Access Compliance Report

(Curb Ramps)

Intersection ID: 44112	Main Street: RIDING_HILL_AV	Cross Street: MERSEYSIDE_CT	Location: NE
ADA ID: 70DDEA9B1D98	Ramp Type: BlendTrans1	Initial Pass/Fail: Fail	Overall Compliance: No
Severity Score: 8.75			
Codes/Mitigation Info/Possible Solution		Field Measurements/Component Compliance

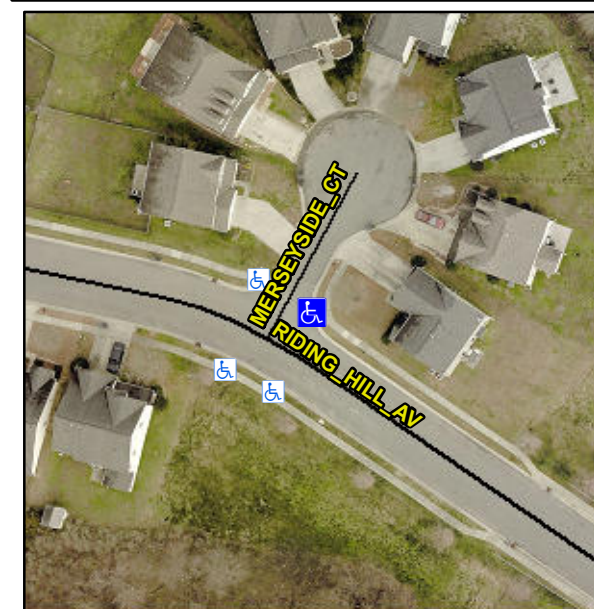
Not Found, R304.5.1

Compliance	Description	Data	Compliance	Description	Data
N/A	Ramp Length (in)	47.0	Yes	BlendTrans Slope (%)	4.4
No	Ramp Width (in)	47.5	Yes	BlendTrans XSlope (%)	1.2
N/A	Flare Type LT	N/A	N/A	Flare Type RT	N/A
N/A	Flare Slope LT (%)	N/A	N/A	Flare Slope RT (%)	N/A
N/A	Flare Traversable LT?	N/A	N/A	Flare Traversable RT?	N/A
N/A	Landing Length (in)	N/A	N/A	DWS Provided?	N/A
N/A	Landing Width (in)	N/A	N/A	DWS Contrast?	N/A
N/A	Landing Slope (%)	N/A	N/A	DWS Length (in)	N/A
N/A	Landing X Slope (%)	N/A	N/A	DWS Full Width?	N/A
N/A	Landing Curb? (Y/N)	N/A	N/A	DWS Offset (in)	N/A
N/A	Shared Landing?	N/A			
N/A	Gutter Ponding?	N/A	N/A	Gutter Slope (%)	N/A
N/A	Gutter Lip Ht (in)	N/A	N/A	Gutter X Slope (%)	N/A
N/A	Painted X Walk1?	No	N/A	Painted X Walk2?	No
	X Walk 1 Direction	To NW		X Walk 2 Direction	To SW
	X Walk 1 Width (in)	N/A		X Walk 2 Width (in)	N/A
	X Walk 1 Slope (%)	4.0		X Walk 2 Slope (%)	3.3
	X Walk 1 X Slope (%)	0.2		X Walk 2 X Slope (%)	3.8

N/A	Ramp inside XWalk1?	N/A	N/A	Ramp inside XWalk2?	N/A
	Road Slope (%)	1.3		Clear Space?	N/A
	Road X Slope (%)	4.4	N/A	Clear Space to XWalk (in)	N/A
N/A	Any Obstructions?	N/A	N/A	Storm Grate/Utility Hazard?	N/A
	Obstruction Type			Storm Grate/Utility Type	
		N/A			N/A
			Yes	Surface Condition? (G/P)	Good
			No	Curb Slope (%)	8.6

Remove & Replace Curb Ramp With Two New Directional Ramps or Equivalent.
